Electronics and Readout Integrations

Answers to Question #7

Cost & Schedule Review for ND-LAr 2x2 Demonstrator

August 2 – 4, 2021

Power Supply List

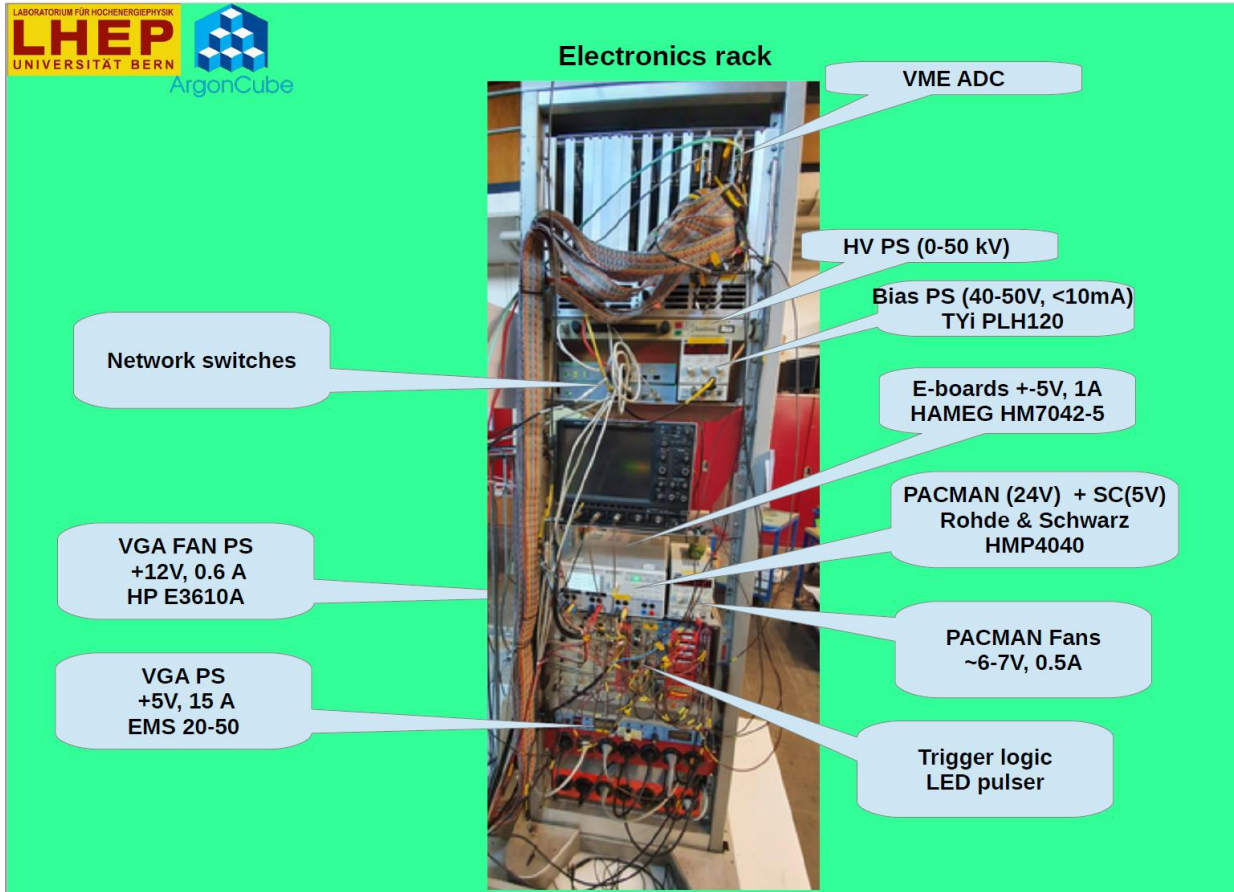
- 7. What will the Wiener power supplies be used for, and if it's to power the 2x2 electronics, does this mean that the DC power supplies used at Bern are not going to be used at Fermilab?
- The MINOS Wiener power supplies are used to power the VME64X crates used for the Light readout system (ADC). Light requires 2 crates + supplies. We will also prepare a spare crate/power supply assembly.
- MINOS Wieners can also be used for VGA Power Supply and Fans, E-boards.
- We will be using the BERN HV Drift power supply.
